Sundry Print Report

Well Name: FRENCH 9004 JVP Well Location: T18S / R32E / SEC 24 / County or Parish/State: LEA /

Notice of Intent

PLUG AND ABANDONMENT CONDITIONS OF APPROVAL

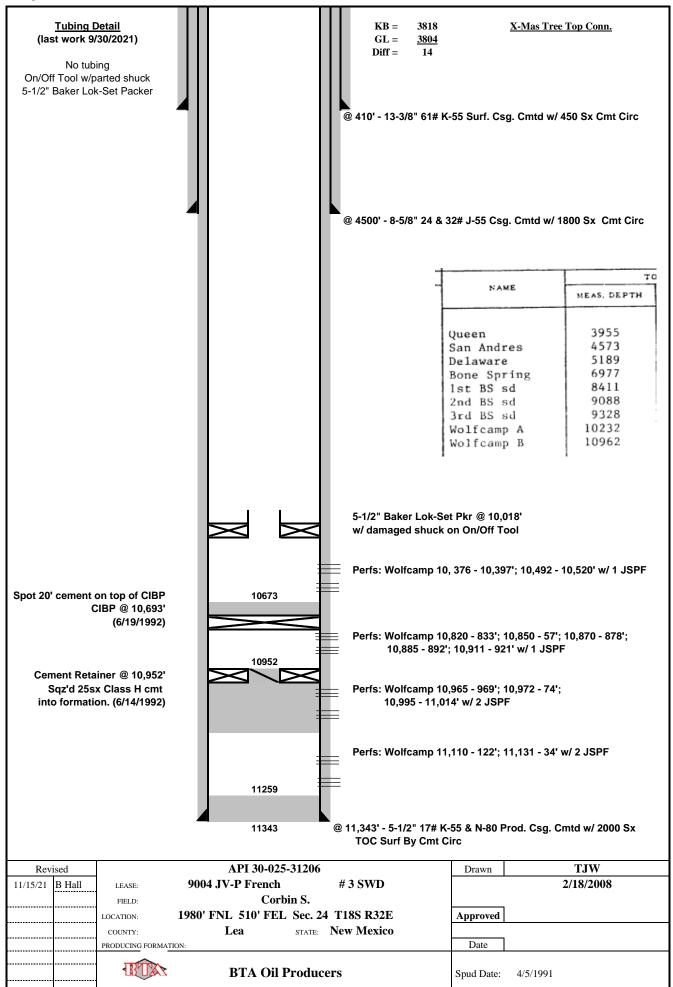
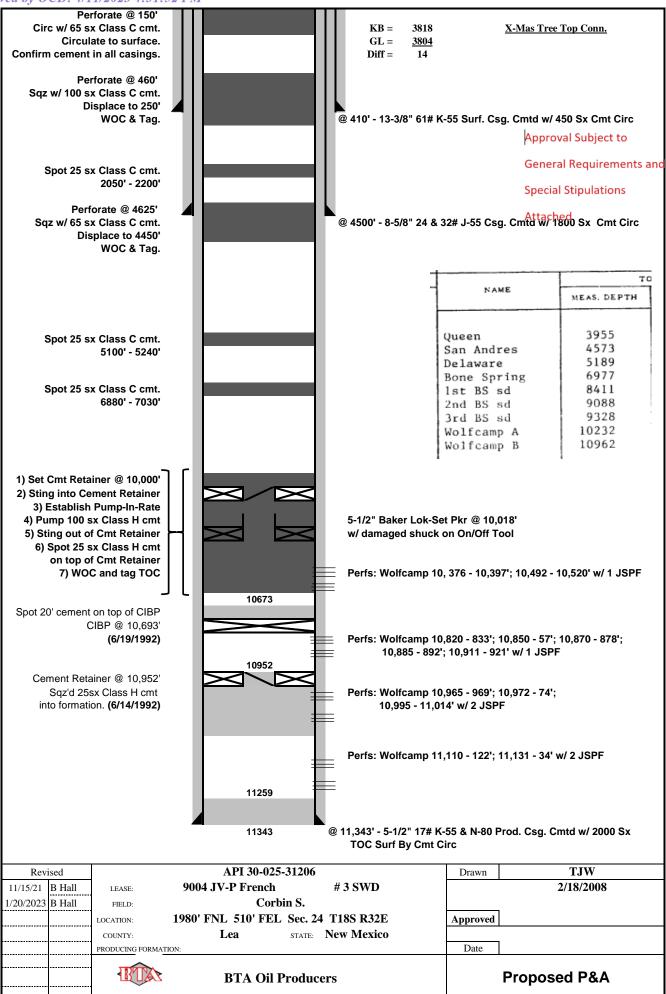
- 1. RIH w/ 5-1/2" Cement Retainer & set @ 10,000'. RD Wireline Unit.
- RIH with workstring to sting into Cement Retainer. Establish Pump-in-Rate into perfs @ 10,376'
 10,520'. Mix & Pump 100 sx Class H cmt through Cement Retainer.

- 3. Sting out of Cement Retainer. Spot 25 sx Class H cement on top of retainer. (If unable to establish Pump-In-Rate, sting out of retainer. Spot 25 sx Class H cement on top of retainer.)

- 4. PU to WOC. RIH to Tag TOC. Circulate hole with 9.5 PPG MLF. Pressure test casing to 500 PSI.
- 5. Spot 25 sx Class C cmt @ 7030' 6857'. (Bone Springs)

- 6. Spot 46 sx Class C cmt @ 5006' to 4543'. (Delaware, Capitan Reef) WOC and Tag.
- 7. Perforate and squeeze 65 sx Class C cmt @ 4625'. Displace to 4450'. WOC & Tag.

- 8. Spot 25 sx Class C cmt @ 2880' to 2629'. WOC and Tag. (Yates, Base of Salt)
- 9. Spot 25 sx Class C cmt @ 1175' to 1063'. WOC and Tag. (Top of Salt)

- 10. Perforate and squeeze 100 sx Class C cmt @ 460'. Displace to 250'. WOC & Tag
- 11. Perforate and squeeze 65 sx Class C cmt @ 150'. Circulate cmt to surface.

- No more than 3000 feet between cement plugs in cased hole.
- Wait on Cement and Tag Top of Cement Requirement:
 - 1. Shoe, Top of Salt, Base of Salt, DV tool, Perforate and Squeeze, Open Perforation.
 - 2. Formation plug is optional if a solid base is established and confirmed.
